UNITED STATES  
 NUCLEAR REGULATORY COMMISSION  
 REGION II  
 101 MARIETTA STREET, N.W.  
 ATLANTA, GEORGIA 30323

Report Nos.: 50-348/88-20 and 50-364/88-20

Facility name: Farley 1 and 2

Inspection Conducted: May 16 - 20 and June 6 - 10, 1988

## FNP 2, N42

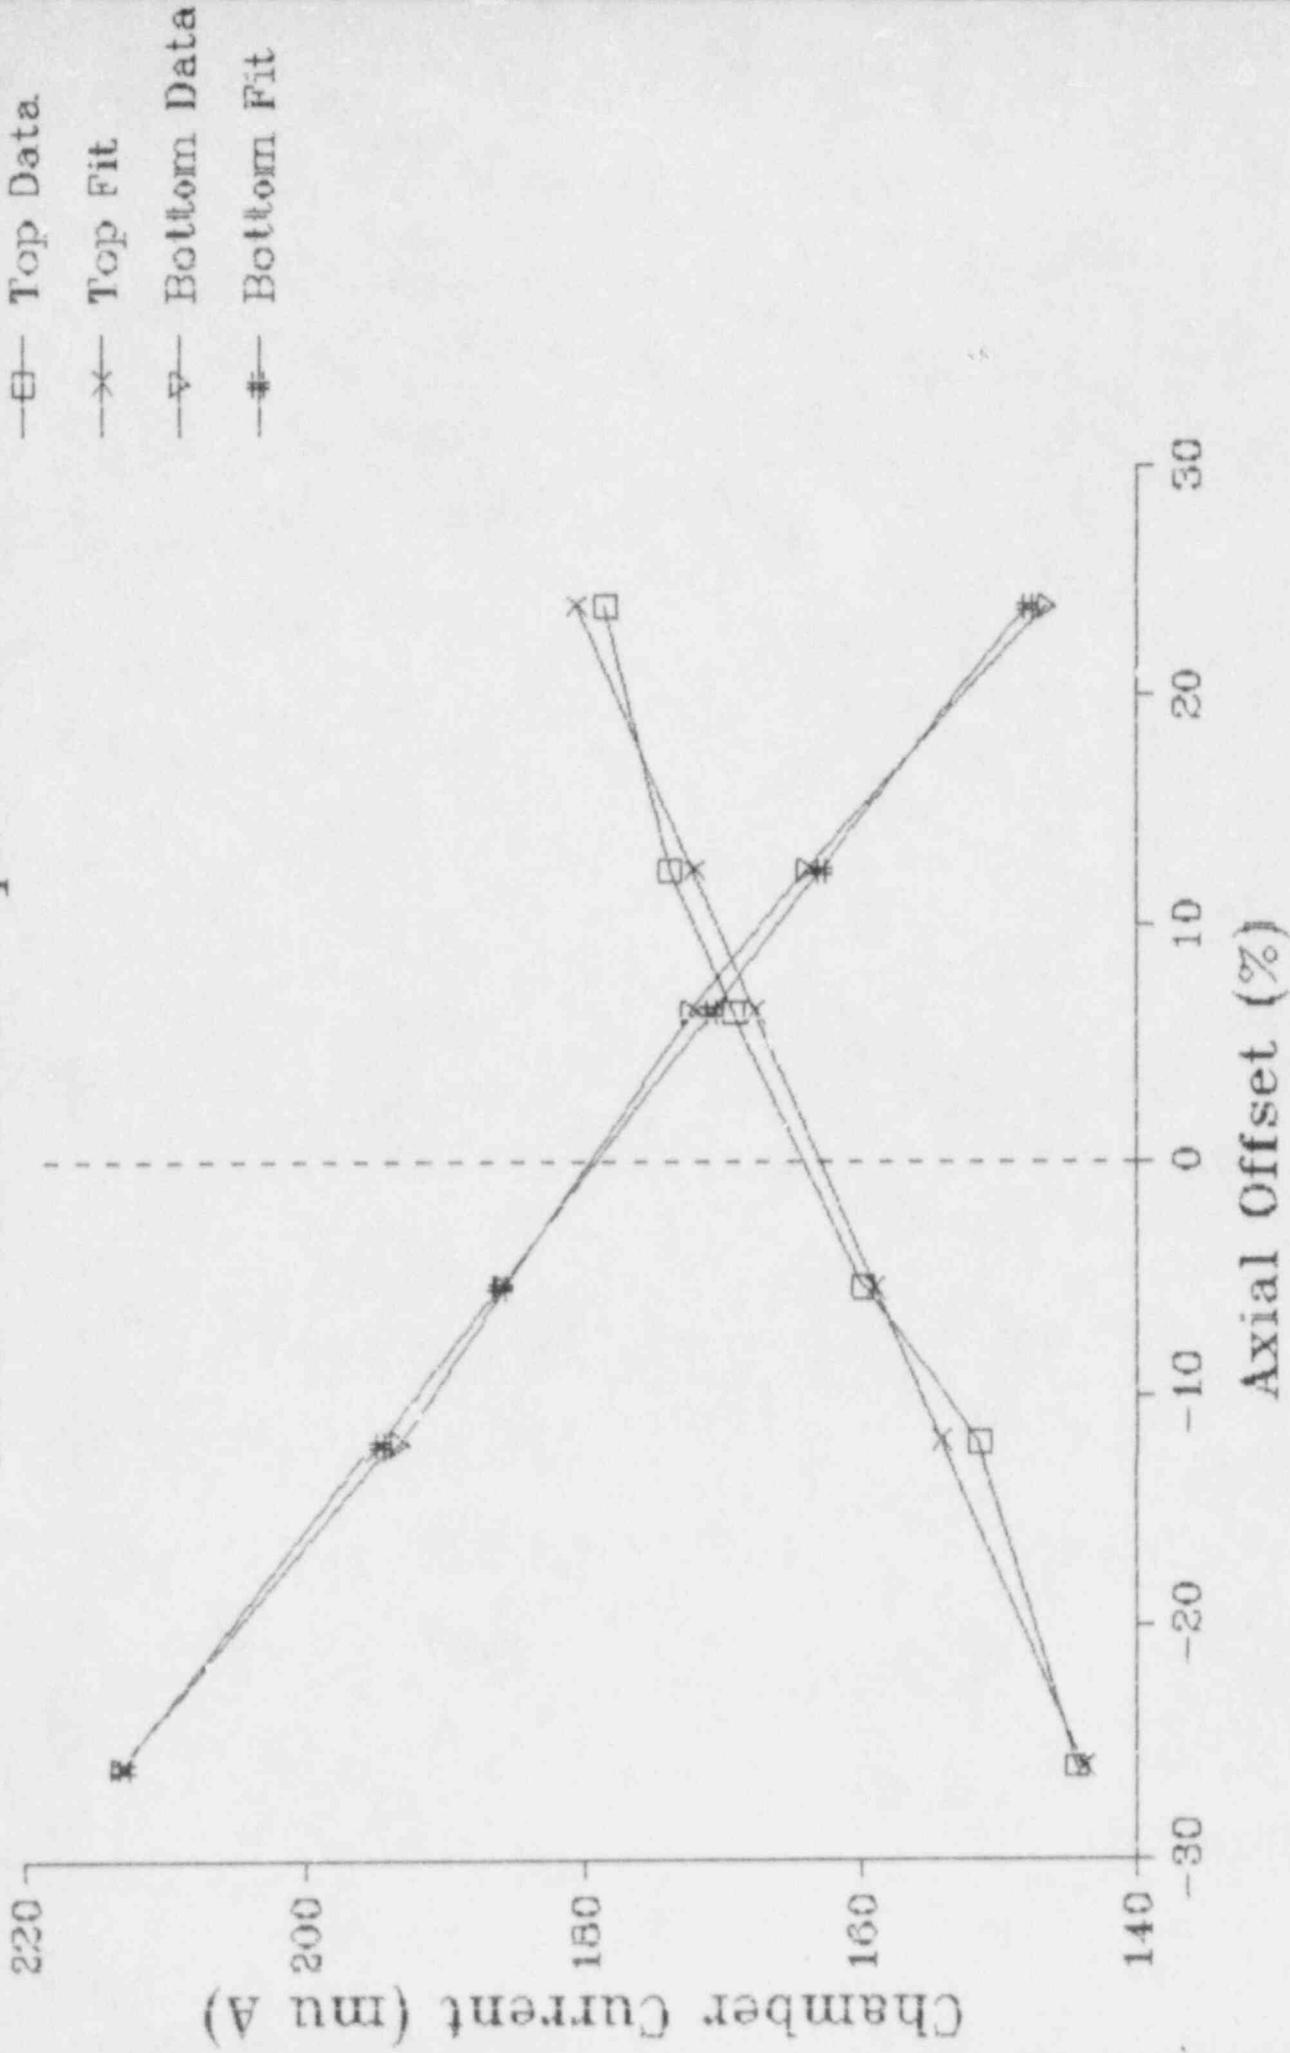
The inspector independently analyzed the incore-excore correlation data using a least squares spreadsheet with the microcomputer program SUPERCALC3 (Release 2.1). For the eight neutron chambers involved, the correlation coefficients ranged from 0.973 to 0.994. The inspector is accustomed to finding all coefficients in excess of 0.99 when the data for the correlation were obtained in the range of 50 to 75% RTP. Attachment 1 is a typical plot of correlation data and results for the pair of chambers comprising Unit 2 PRNI N#2.

In the second week of the inspection, incore-excore correlation data were available from the recent startup of Unit 1 (Procedure FNP-1-STP-121). A similar analysis of those data yielded correlation coefficients in the range 0.985 to 0.999. Attachment 2 is a typical plot of correlation data and results for the pair of chambers comprising Unit 1 PRNI N44. As power was escalated on Unit 1, additional flux maps were obtained at 50 and 80% RTP. Those results were used to adjust rather than augment the earlier correlations. The adjustments affected only the zero offset currents and not the slopes of the offset versus current relationships. The methodology used and the bases for those adjustments will be reviewed in later inspection.

The currents produced by the chambers are only 40 to 50% of those observed for similar instruments at other facilities. Hence at the relatively low powers, about 30% RTP, that the licensee uses for the incore-excore correlation, chamber currents are only 40 to 60 microamperes. Thus the observed currents are resolved to only two significant figures instead of the three available at other facilities. The low currents appear to have a direct and negative impact on the quality of the correlations. The inspector referred the licensee to another facility that has been successful in increasing the currents produced by the PRNIs.
